ADDENDUM NO. 2

March 1, 2022

**TIMOTHY BALL ELEMENTARY SCHOOL ADDITIONS, RENOVATIONS,
AND RELATED WORK
Crown Point, IN 46307**

This Addendum forms a part of and modifies the Bidding Requirements, Contract Forms, Contract Conditions, the Specifications, and the Drawings dated February 7, 2022 by Gibraltar Design. Acknowledge receipt of the Addendum in the space provided on the Bid Form. Failure to do so may subject the Bidder to disqualification.

UNIT "A" ARCHITECTURAL SECOND FLOOR DEMOLITION PLAN
SCALE: 1/8" = 1'-0"

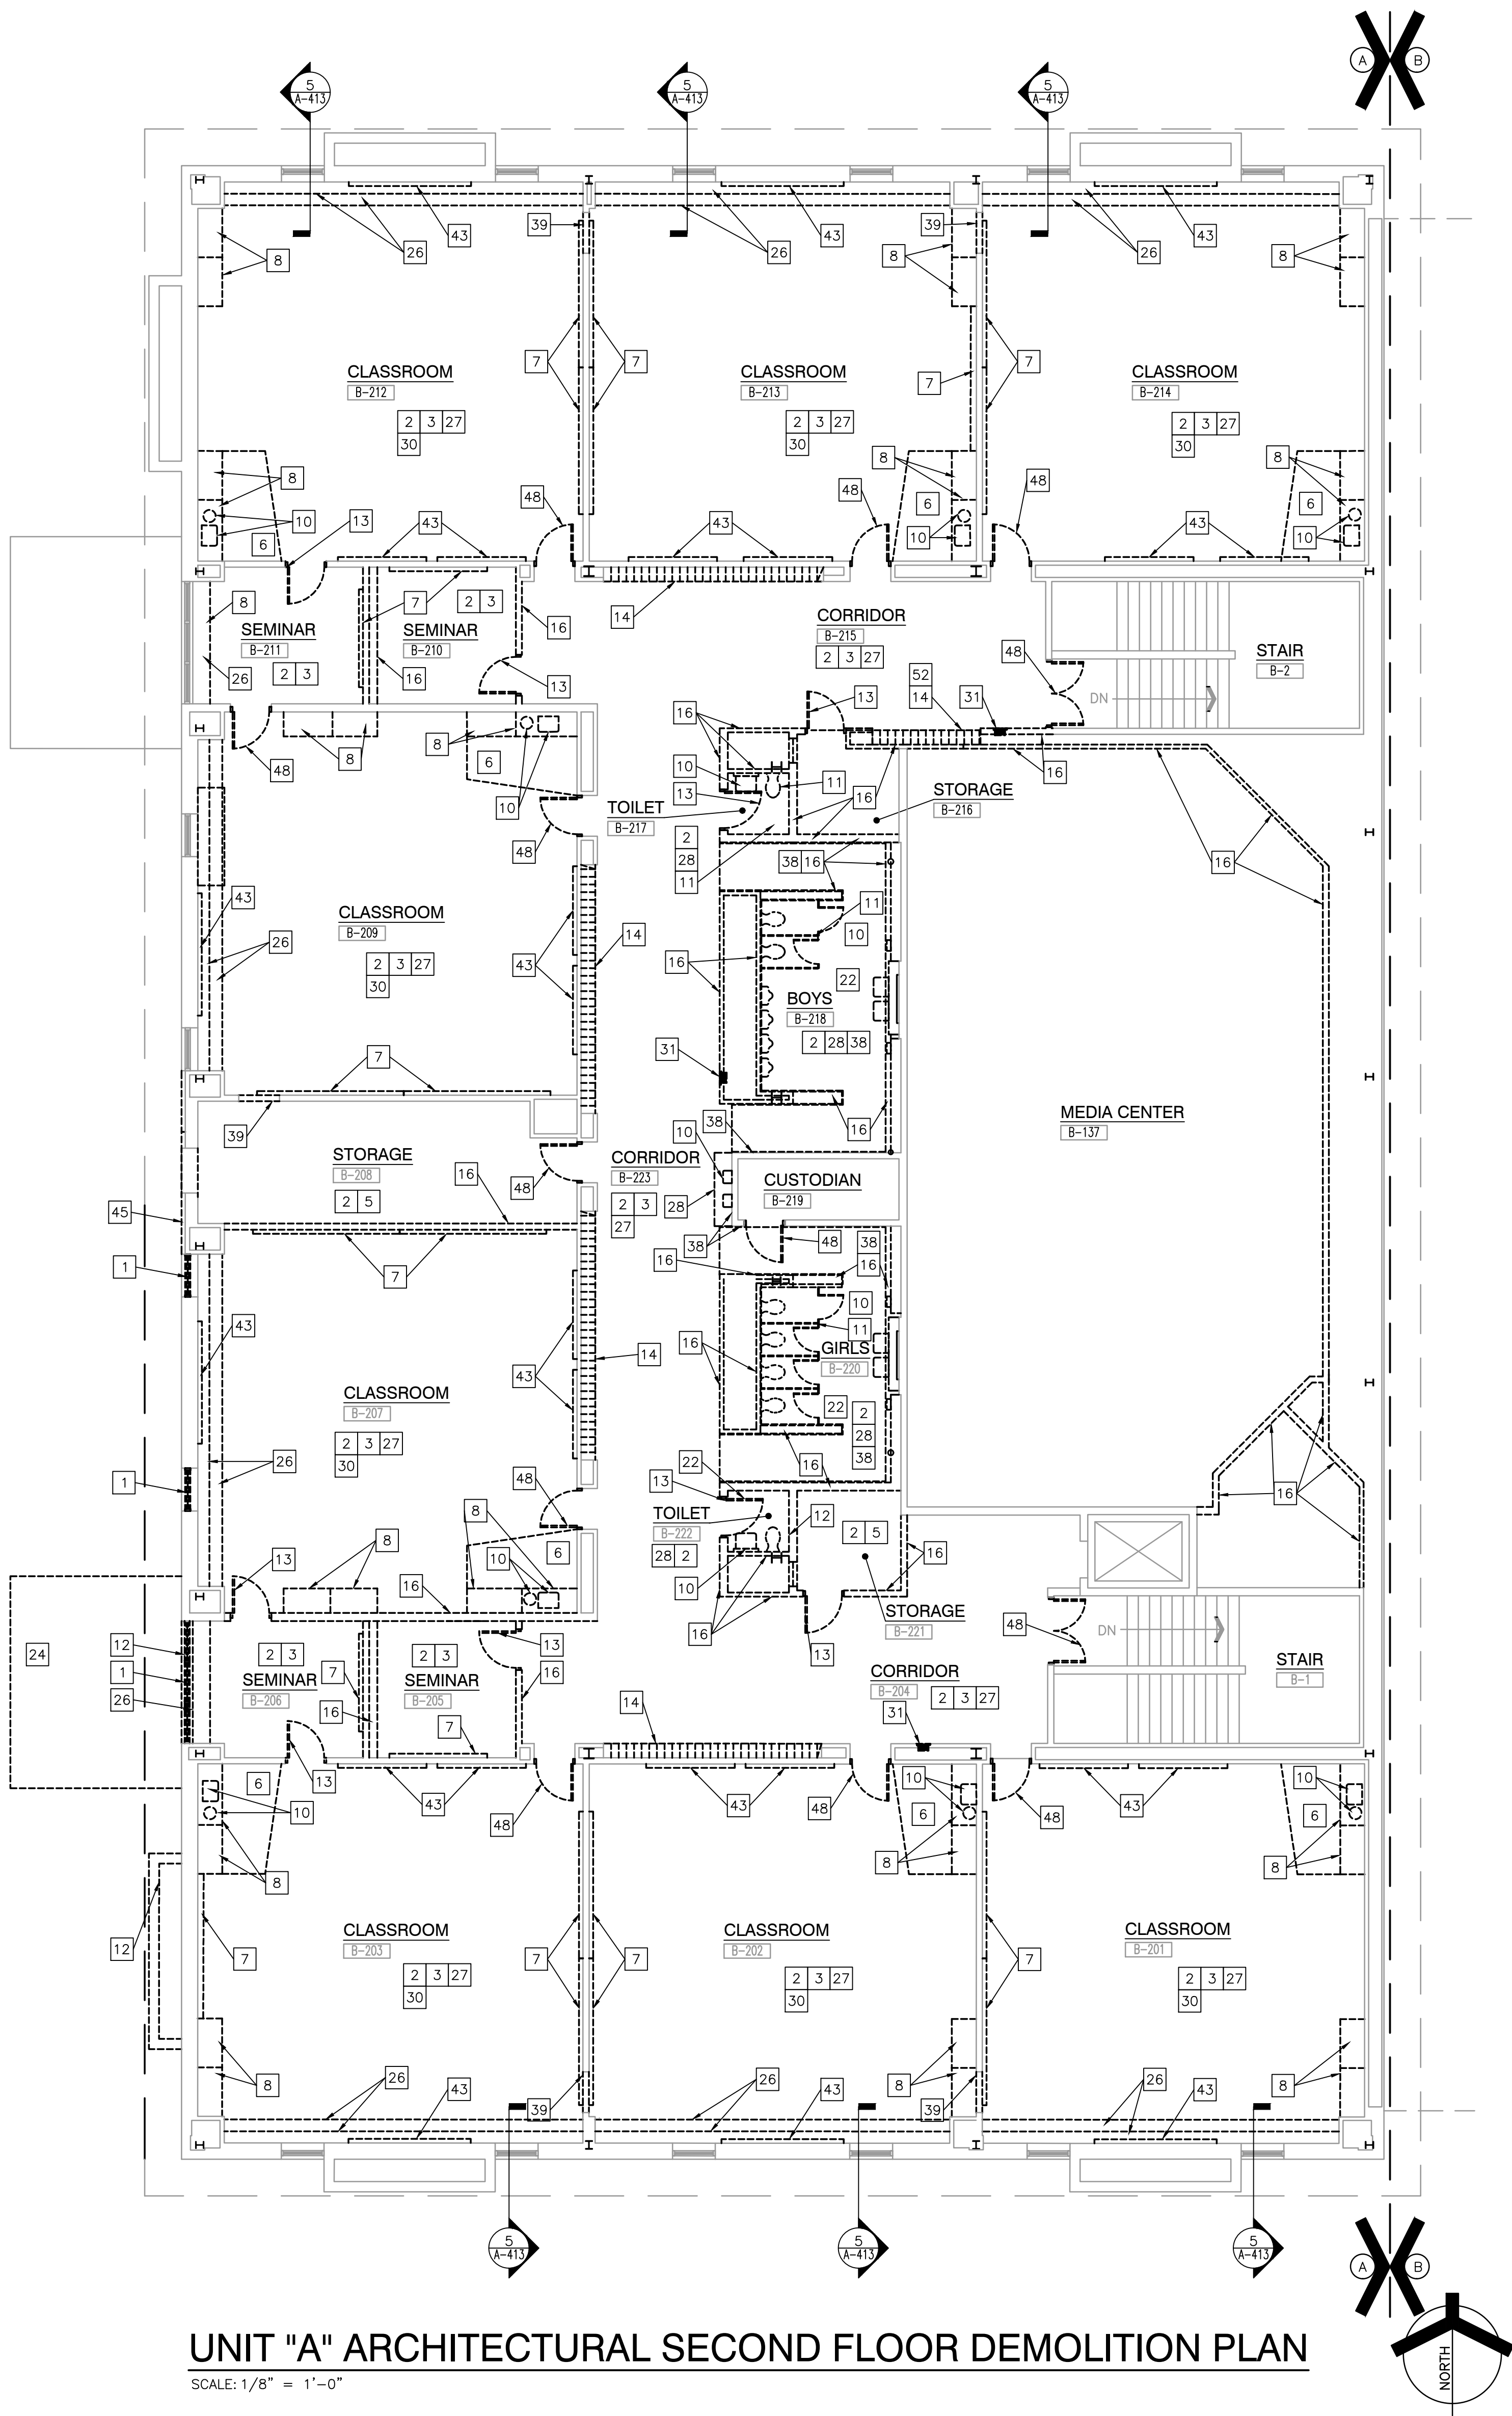
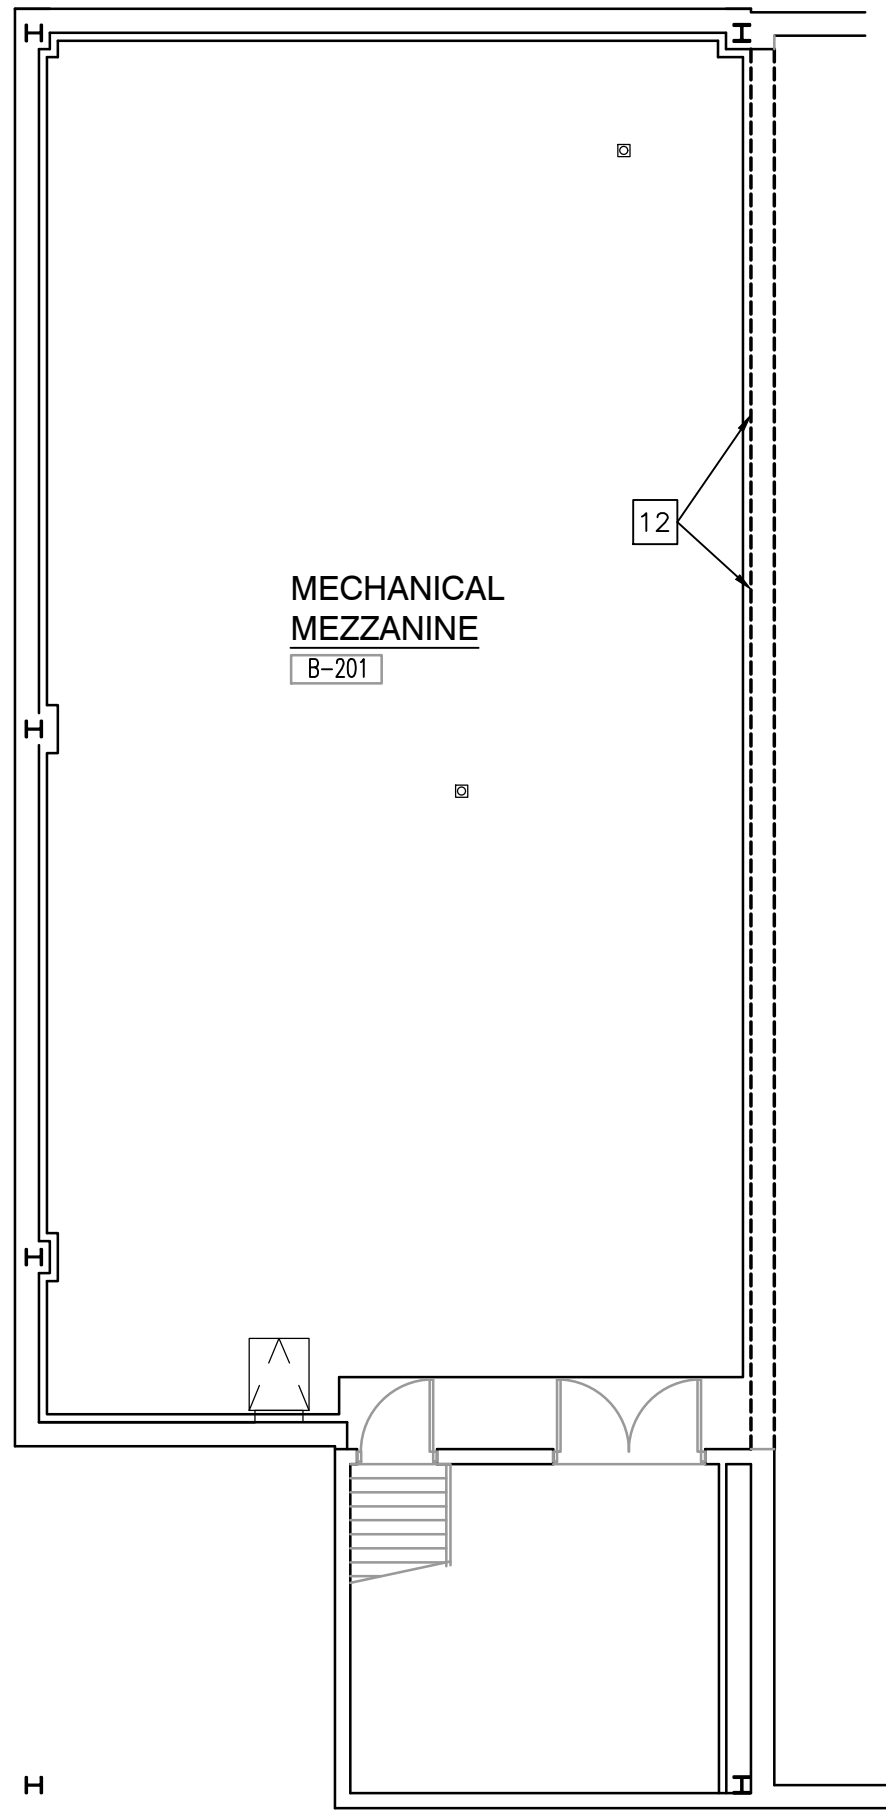
6. Sheet AD-101, AD-102, AD-103

1. Add General Demolition Note Y.
2. Revise Plan Note 50, 26.
3. Add Plan Notes 55, 56, 57, 58.
4. Refer to Demolition Floor Plan for clouded revisions in multiple locations.

UNIT "A" ARCHITECTURAL FIRST FLOOR PLAN

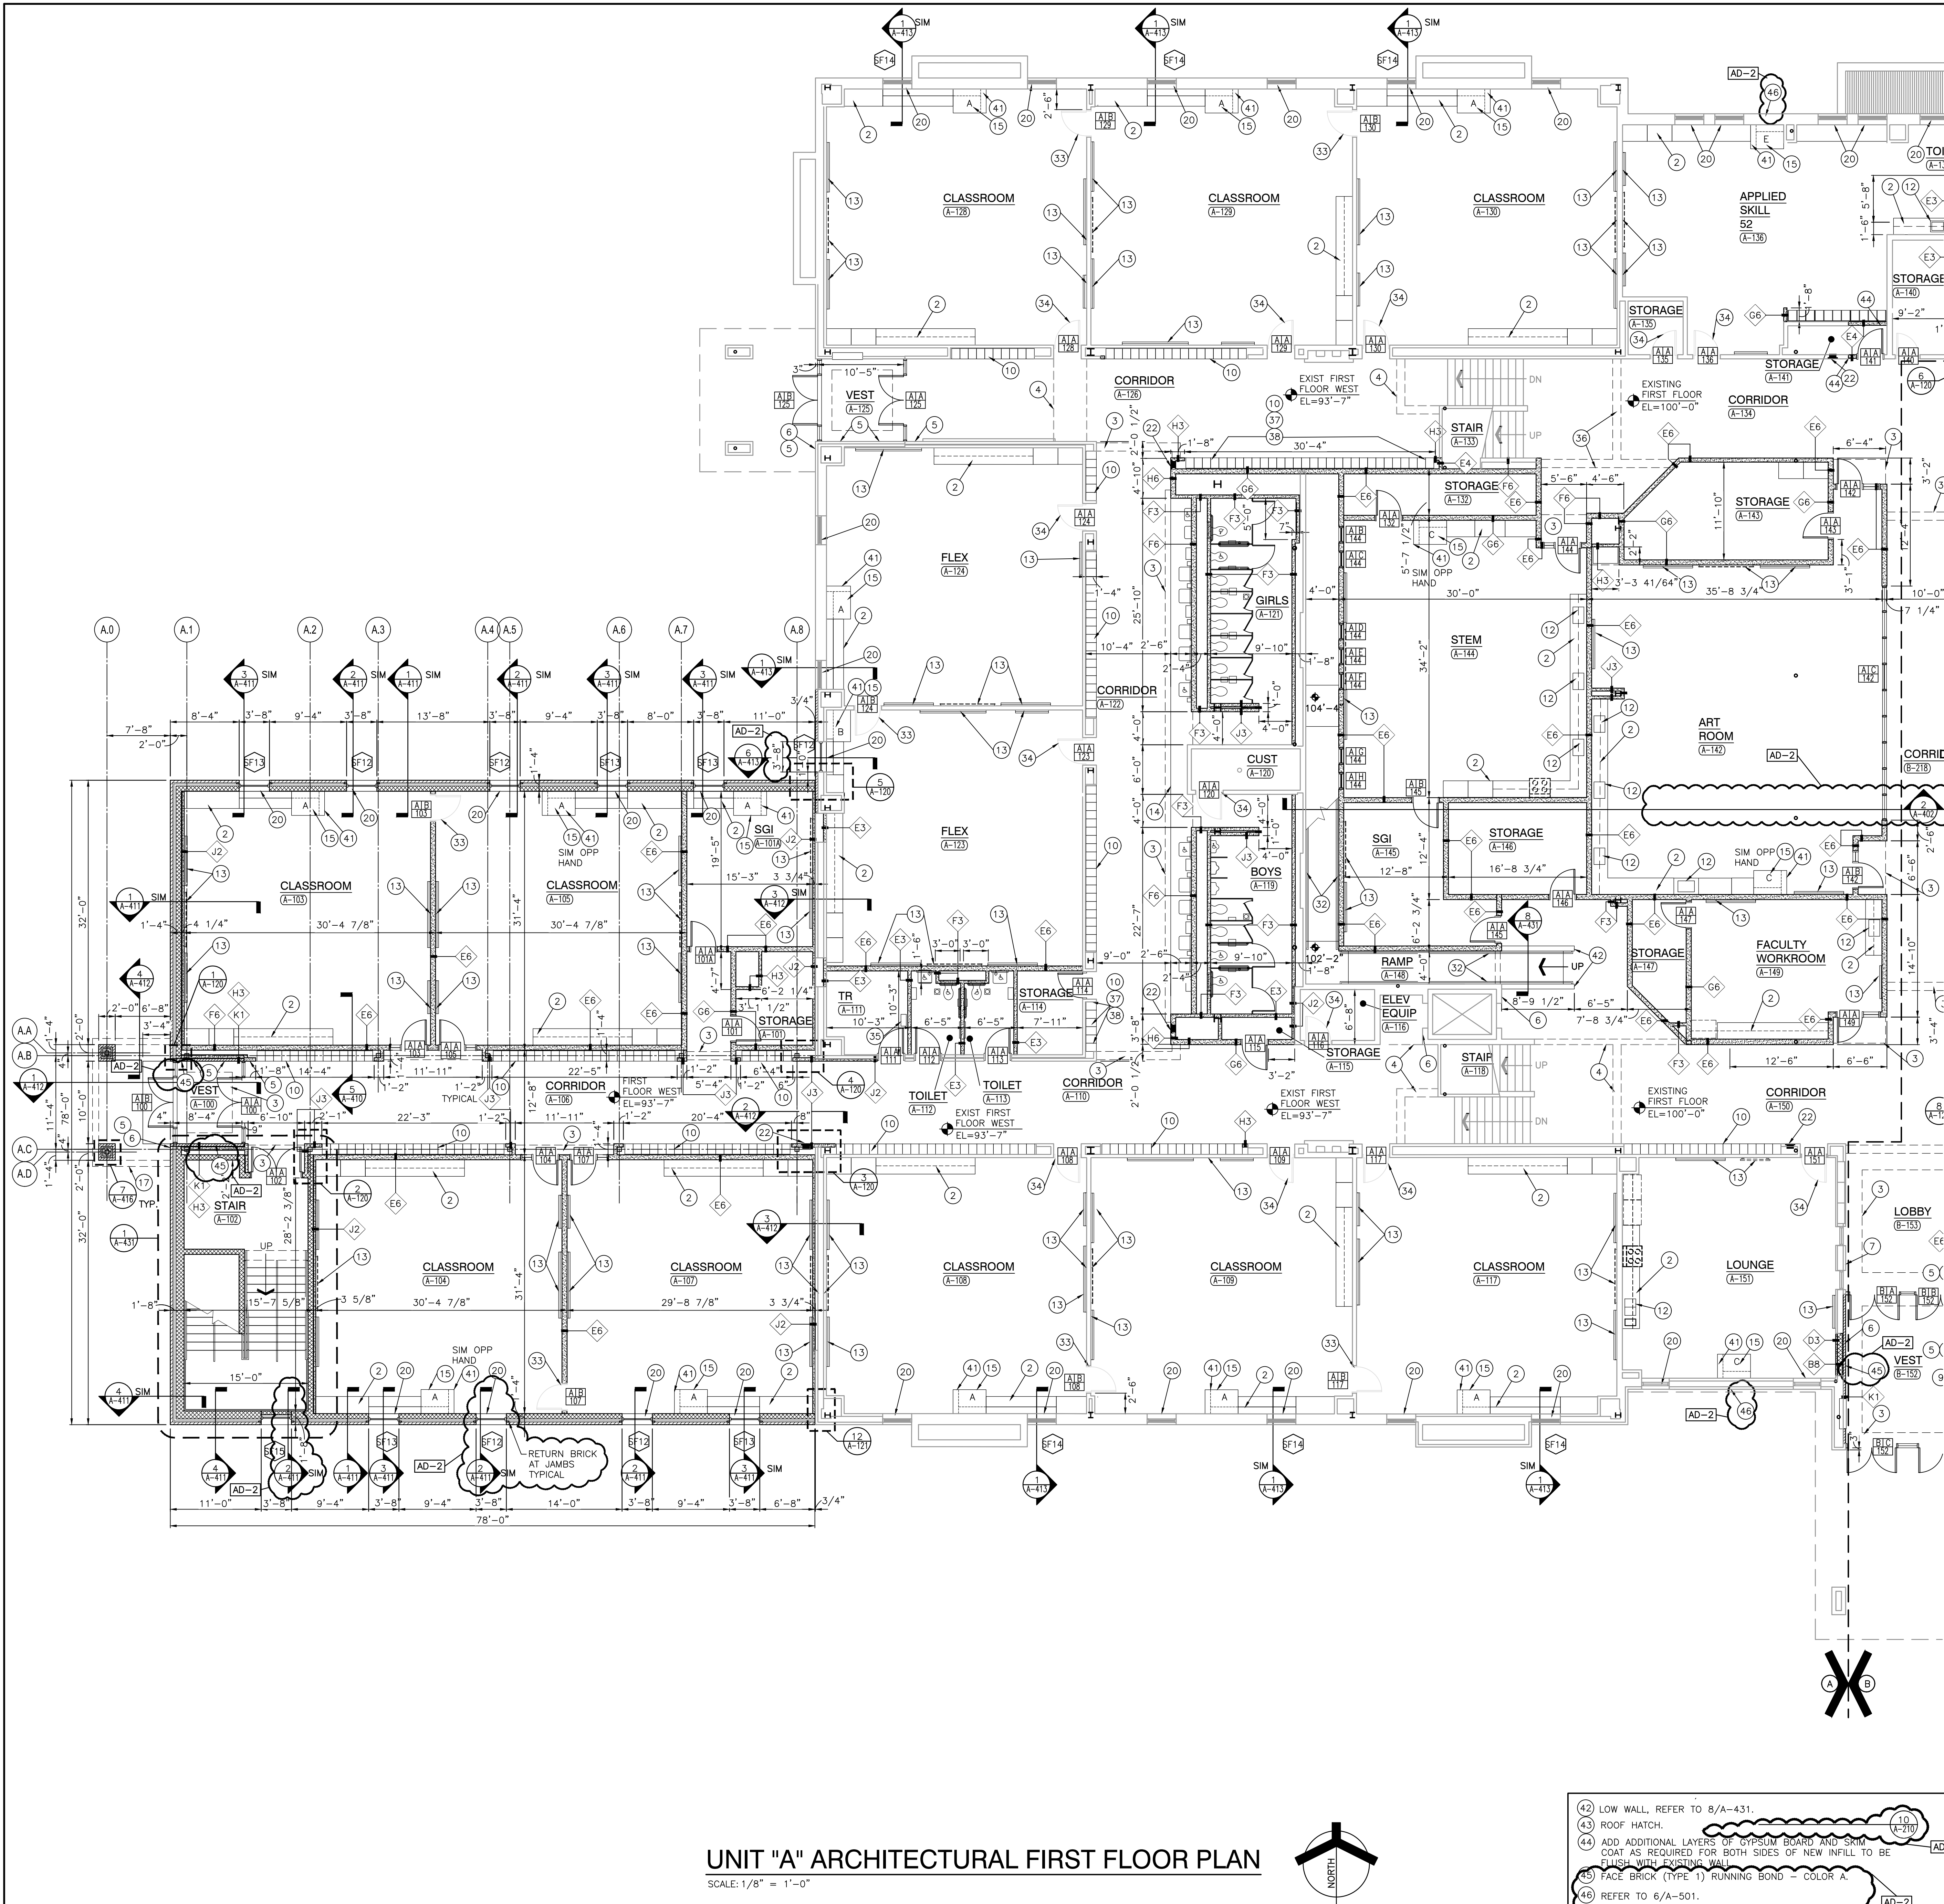
7. Sheet A-101, A-102, A-103, A-104, A-105

1. Add Plan Notes 45, 46.
2. Revise Plan Note 24, 37, 38, 40, 43.
3. Revise section cuts were clouded on plan.
4. Refer to Floor Plan for clouded revisions in multiple locations.
